UNITA' DUAL 12 GOLD

04/03/2015

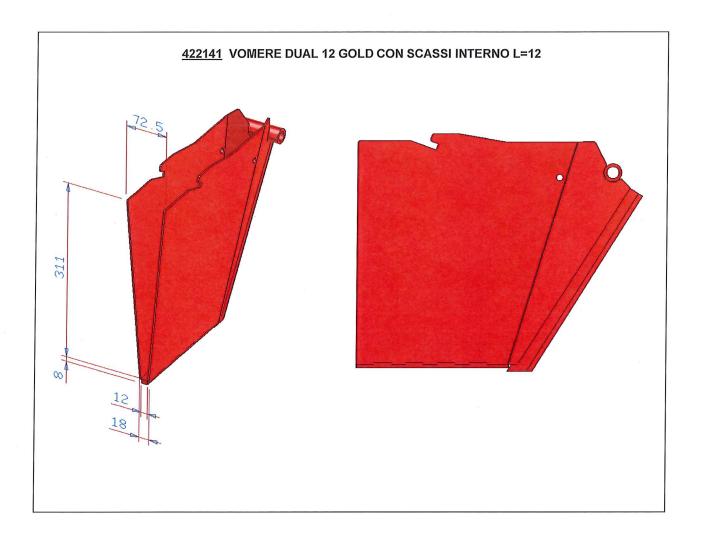
The runner above is a new runner available for the Dual 12 Gold, and is intended for very small plant plugs only. It is NOT recommended that this runner be promoted as a "standard" runner as it has the same high wear characteristics as the early Dual 12 runners. The standard runner, #421586, should still be recommended in all normal situations.
